# **802.3 Ethernet Over SONET Ad Hoc Report**

## **ITU-T SG7 Liaison Communications To IEEE 802**

## ITU-T SG7 Approved Recommendation X.86

# X.86 Ethernet Encapsulation By LAPS

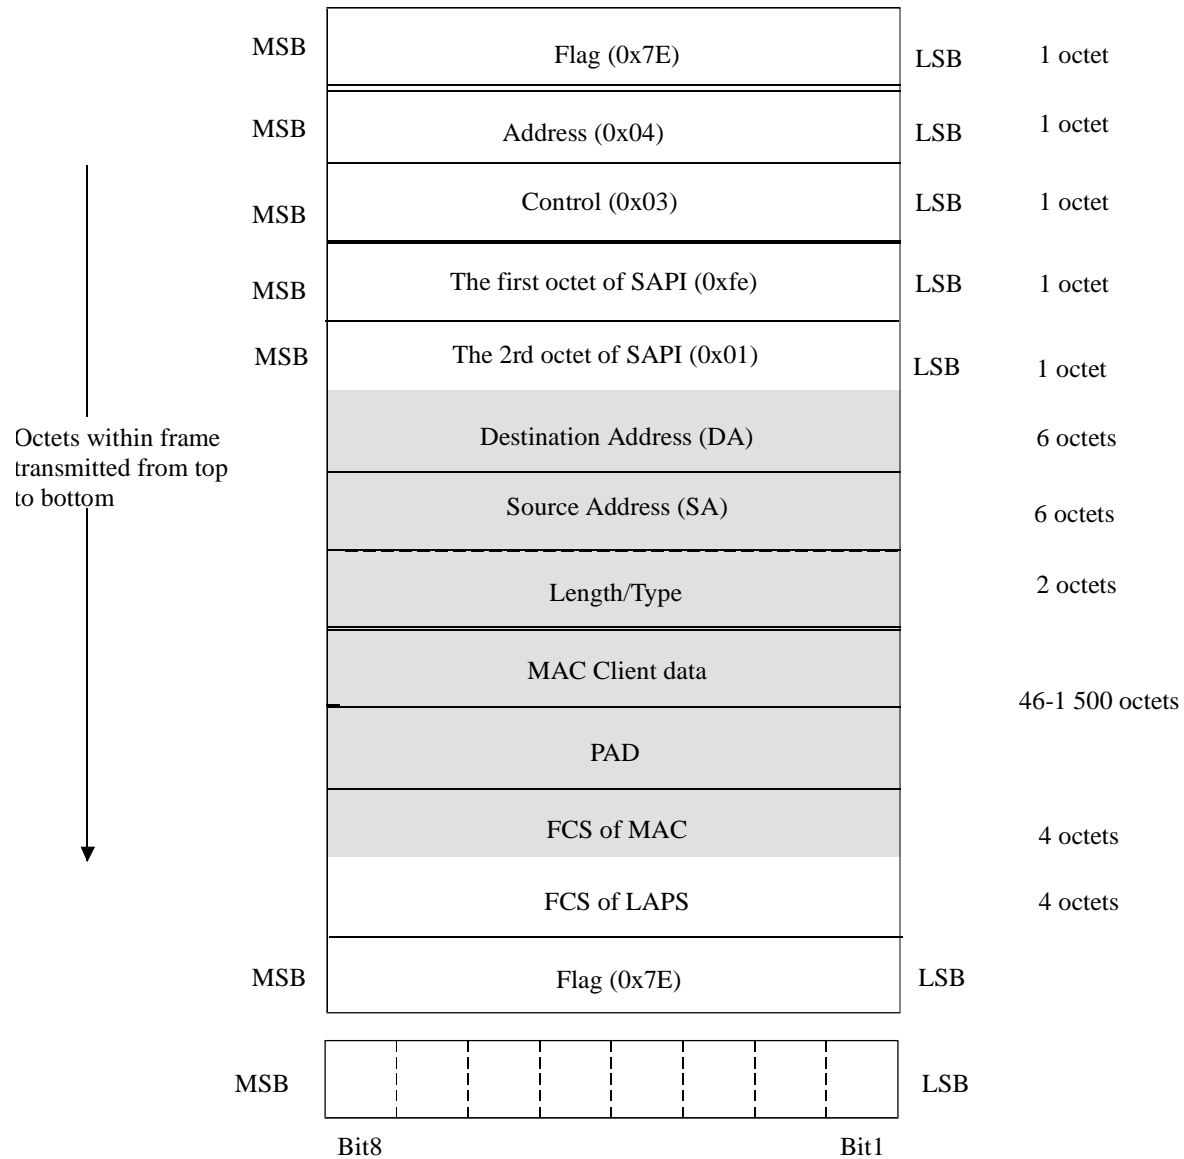
“If the Rate Adaptation is needed in the LAPS transmit processing, transmit entity adds the rate adaptation octet(s) "0xdd" within the frame by sending sequence(s) of {0x7d, 0xdd}. This function is performed just after transparency processing and before the end flag is added. In receive direction, receive entity will remove the Rate Adaptation octet(s) "0xdd" within the LAPS frame when detecting sequence(s) of {0x7d, 0xdd}, This function will be done just before transparency processing and after the end flag is detected.”

This works well with the initial implementation of 100BaseX into SDH VC-4 (150Mb) by expanding the data transfer rate to match the SDH payload rate. This will not work well with mapping Ethernet frames into lower SDH payload rates, such as 1000BaseX into SDH VC-4.

Recommend a motion to respond to ITU-T SG7 with a request to include 802.3x MAC Control Frames (802.3 Clause 31, Appendix 31A) be used as an alternative Rate Adaptation mechanism specific to mapping Ethernet MAC transfer rates into lower SDH Payload Rates.
